RE: **Bosque Brewery**
I-25 west Frontage Rd between Venice & Pasadena
Conceptual Grading and Drainage Report
Stamp Date: 10/24/17
Hydrology File: B18D022

Based upon the information provided in your submittal received 10/24/17, the above referenced submittal cannot be approved for Site Plan for Building Permit or Building Permit until the following comments are addressed:

**RE: I-25 West Frontage Rd between Venice & Pasadena
Conceptual Grading and Drainage Report
Plan Date: 8/3/17
Hydrology File: B18D022**

Attached is the revised Grading & Drainage Plan and supplemental sheets for the proposed development at I-25 West Frontage Road between Venice & Pasadena. The following addresses the comments received on August 22nd, 2017 regarding the submittal to the City of Albuquerque with plan dated August 3rd, 2017:

SHEET NUMBER:
C-1

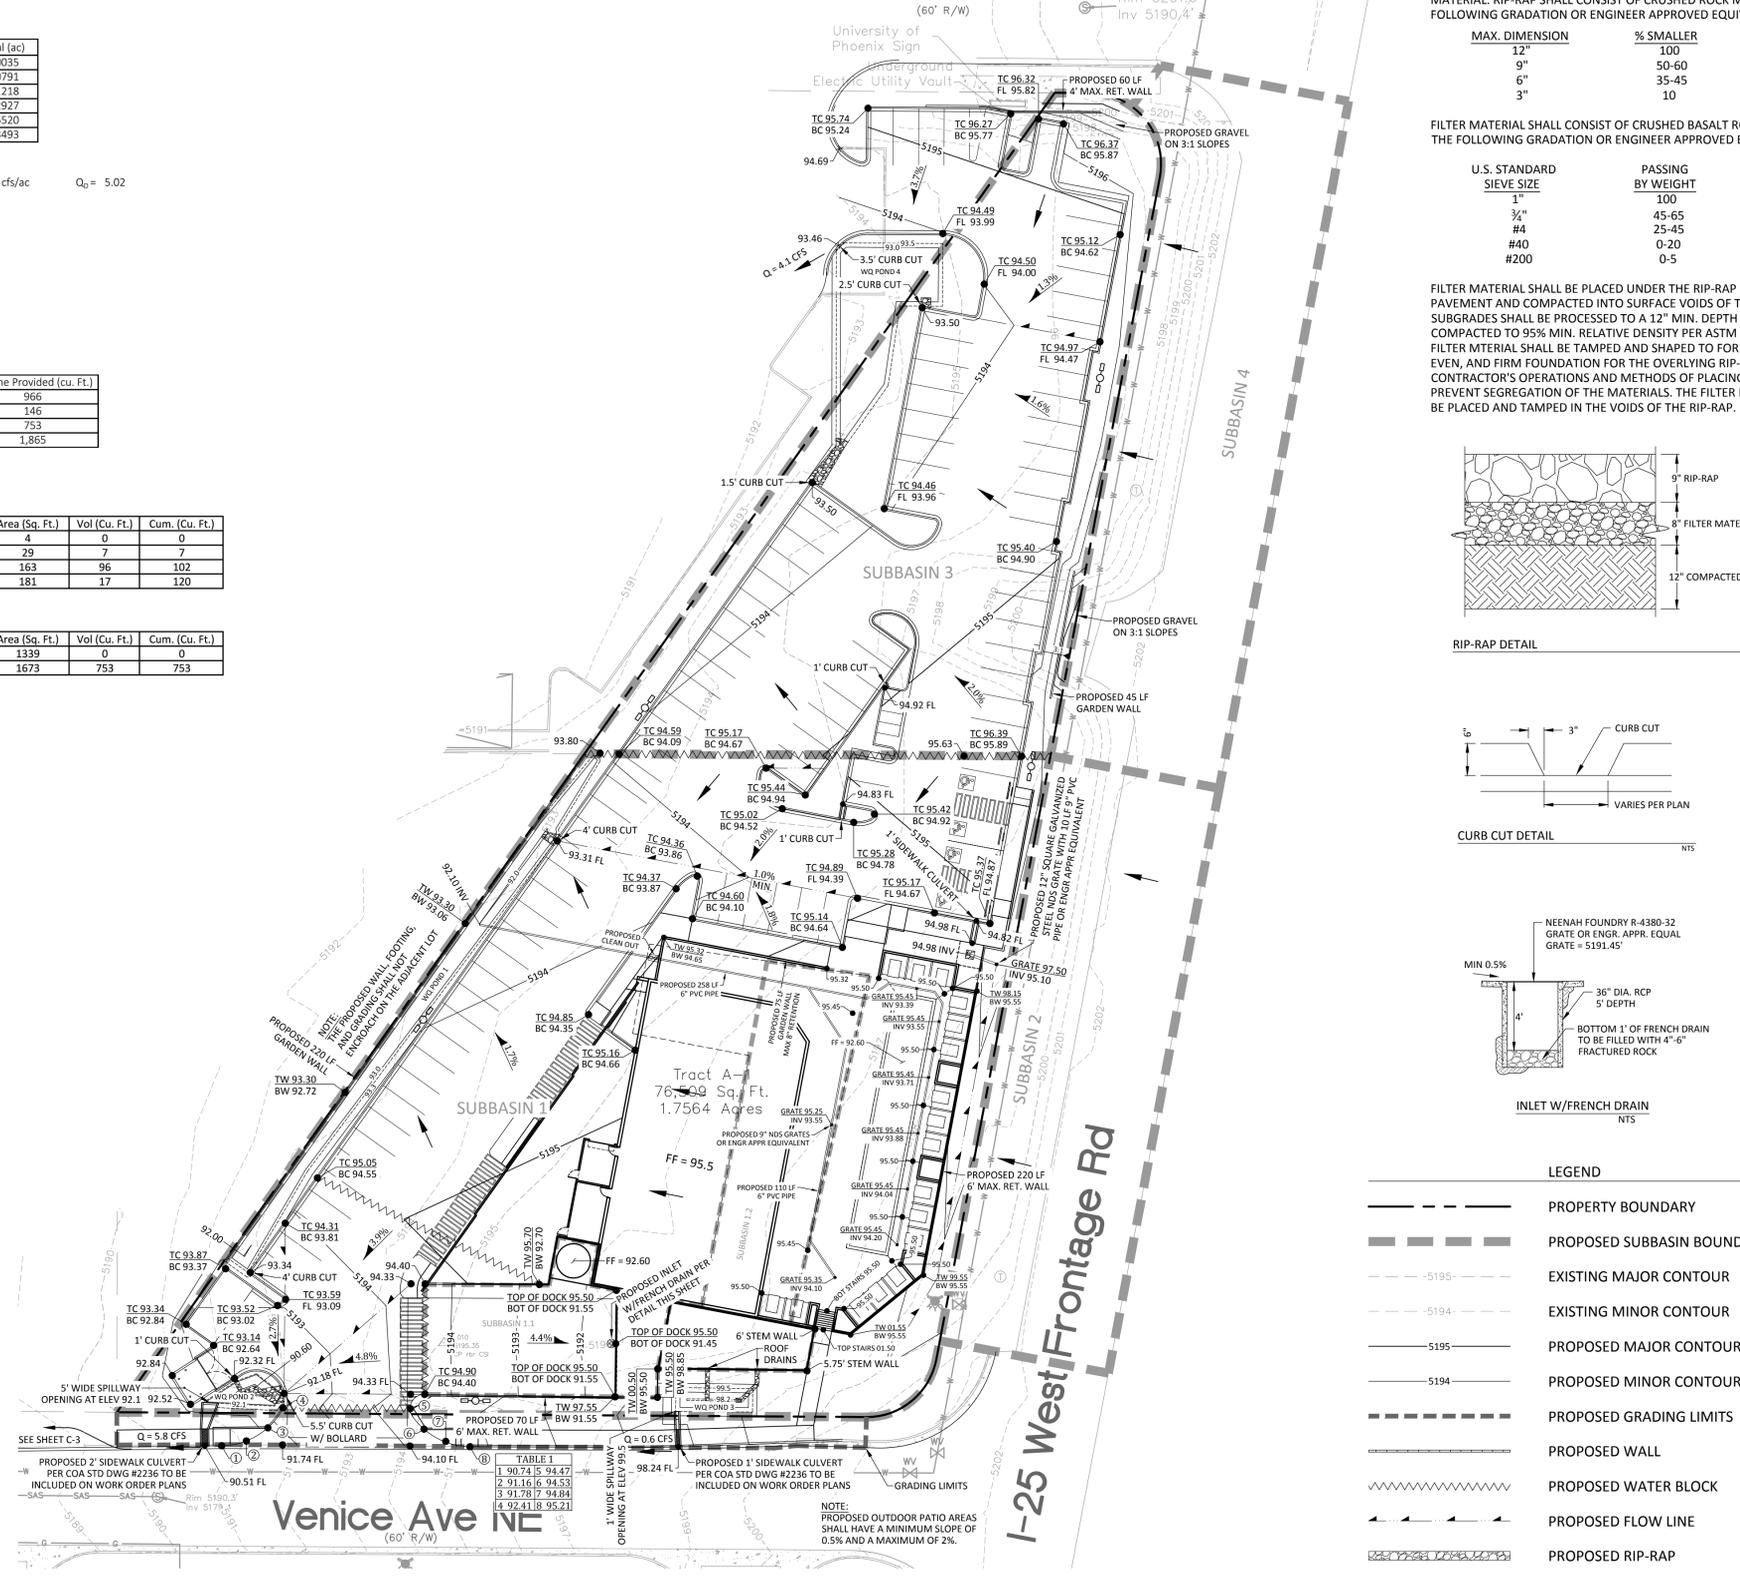
2. Separate subbasin 1 into 2 subbasins, showing what first flush volume flows to WQ Pond 1 vs. WQ Pond 2. Each pond needs to be large enough to retain the first flush volume for its subbasin.

3. WQ Pond 3 needs to be increased to retain 150CF. Alternatively, Fee-in-Lieu may be made for the bypass volume (\$8.00/CF x 4CF) if no other options are available.

4. At the drop inlets on Venice, extend the riprap mattress around the gutter pans (between the gravel shoulder and the gutterpans.
5. At the drop inlets, include a berm or warp the grading to force the swale towards the inlets and keep higher flows from running behind back-of curb.

6. Recommendation: The French drain for subbasin 1.1 appears to only be able to hold 35CF; whereas the first flush volume is 98CF and the 100year, day volume is 1338CF. Please provide additional retention volume to keep the loading dock usable. Additionally this design seems susceptible to clogging and will be maintenance intensive.

6. In section A-A, show the adjacent lot existing grade and the footer (if any); include a note that the wall, footer, and grading will not encroach upon the adjacent lot.

7. For conceptual grading and drainage plans, label as "not for construction."

Section A-A is no longer applicable in these latest plans and, therefore, has been removed. The note stating that the wall, footer, and grading will not encroach upon the adjacent lot has been included on the plan. See revised sheet C-1.

The label "not for construction" has been added. See revised sheet C-1.

SHEET NUMBER:
C-2

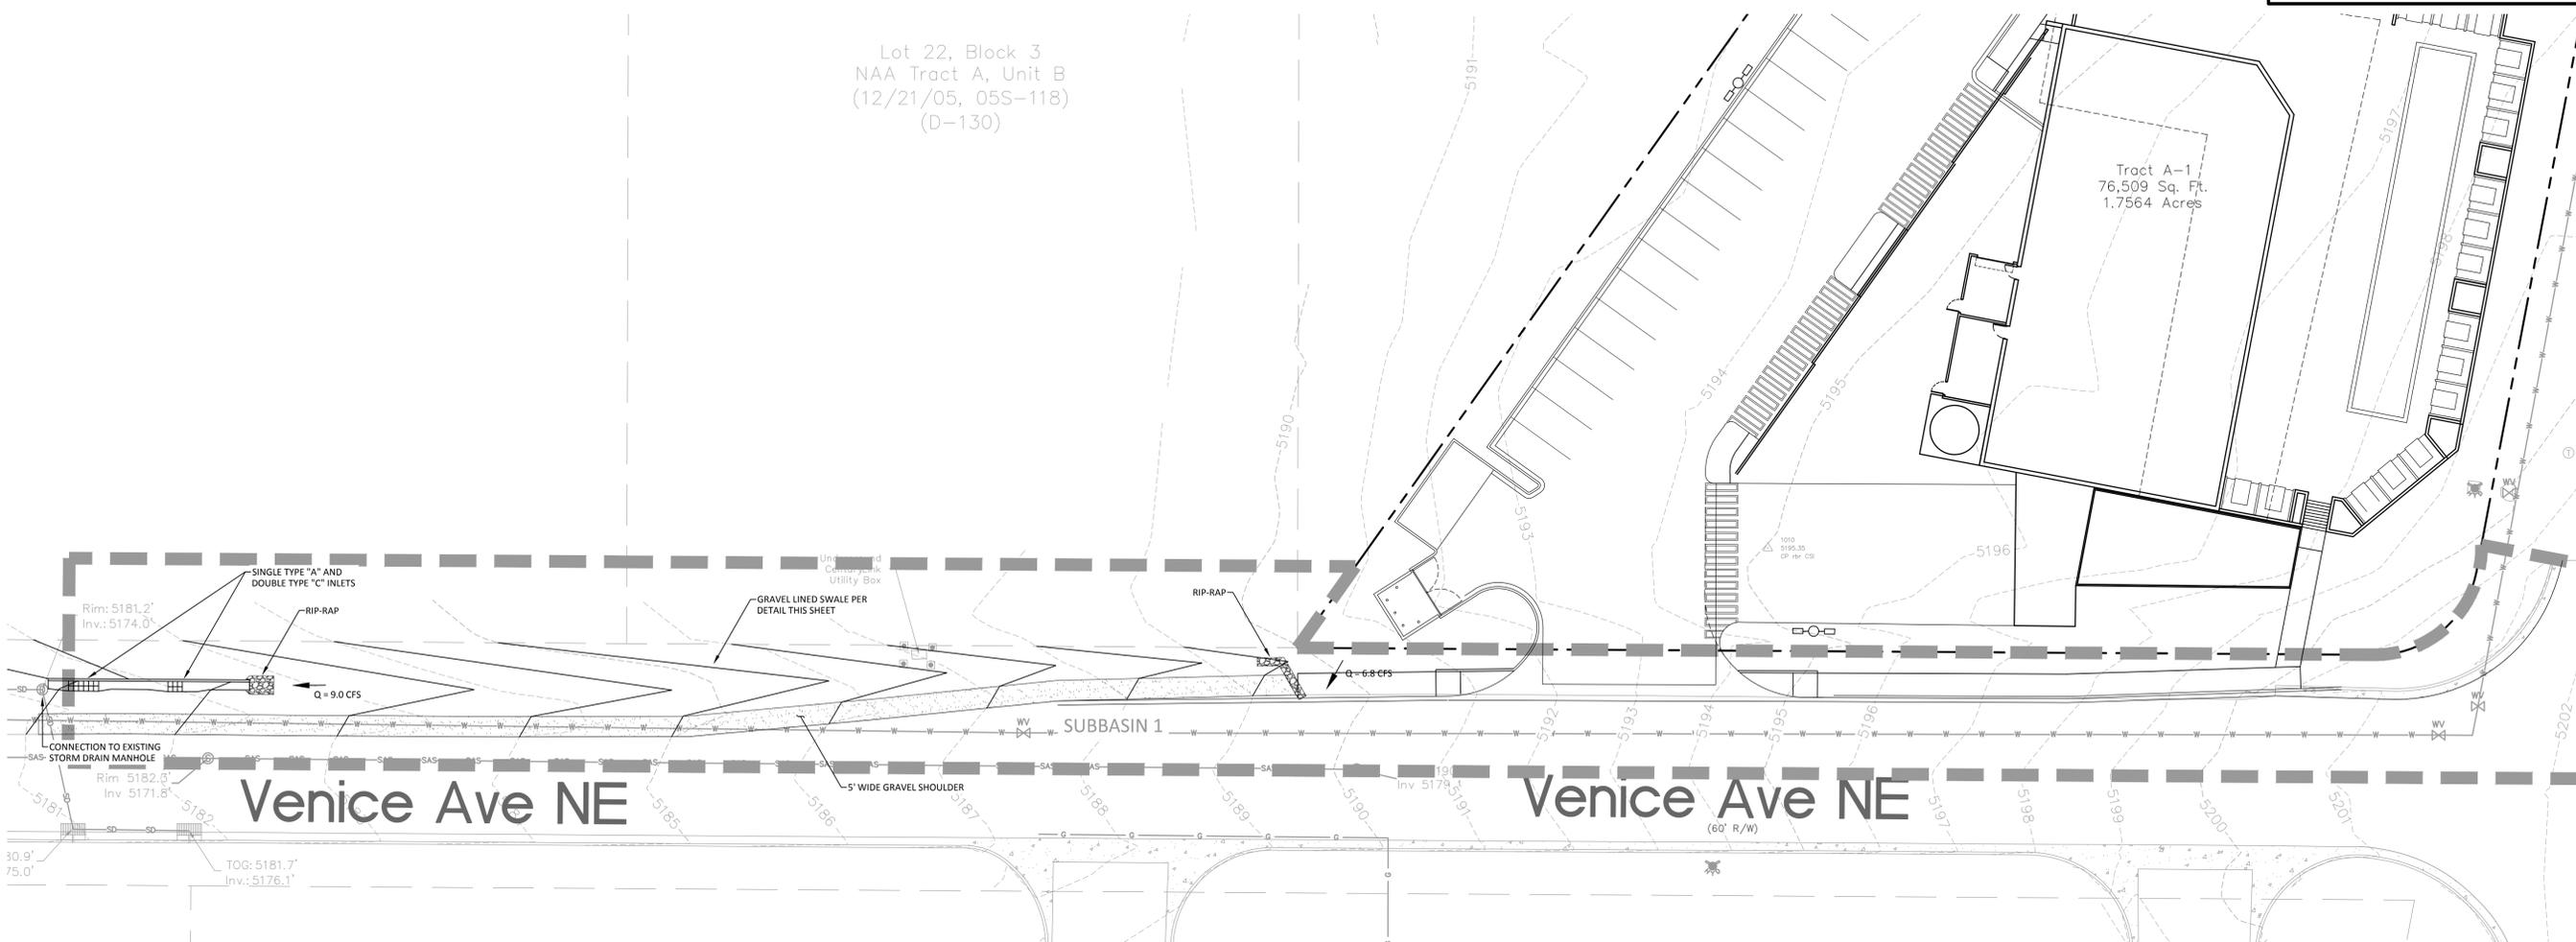
3. The downstream storm drain inlets will need to be built in accordance with the ultimate design: 1x single A and 1x double C.
The Offsite Exhibit has been modified to show single type "A" and double type "C" inlets. See revised sheet C-2.

4. Per Ch. 22, Section C.e(2) of the DPM, channels draining to inlets must be armored. Provide concrete transition slabs and curb for the inlets and standard curb and gutter between the two inlets. Provide riprap protection around the inlets and immediately upstream.
Curb & gutter has been added between the inlets, a 10' sacrificial section of curb & gutter has been added upstream of the single type "A" inlet, and riprap protection is included upstream of the inlets. See revised sheet C-2.

5. Freeboard must be provided for the channel.

As discussed with you and Doug, the swale shall be 1' deep. This provides approximately 0.4' of freeboard. See revised sheet C-2.

Exhibit A
August 2017

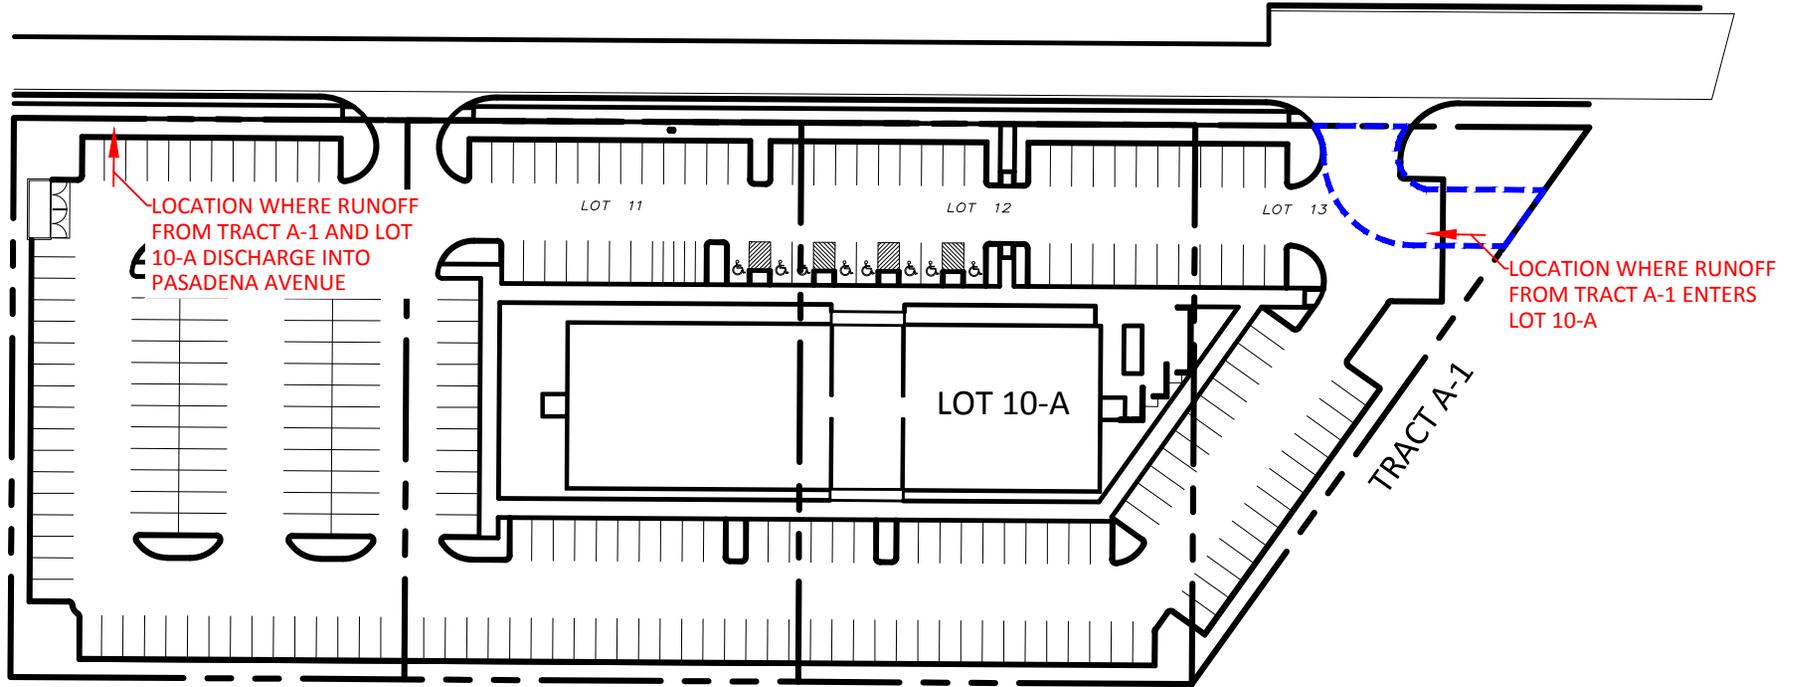
1. A cross lot drainage easement will be required with University of Phoenix in order to discharge onto their lot. In coordination with Transportation, a reciprocal access easement (DPM Ch.23 (6), figure 23.6.3) may modified to include cross lot drainage and must be recorded prior to SPBP approval.

1. A cross lot drainage easement will be required with University of Phoenix in order to discharge onto their lot.
A draft of the cross-lot drainage easement is attached.
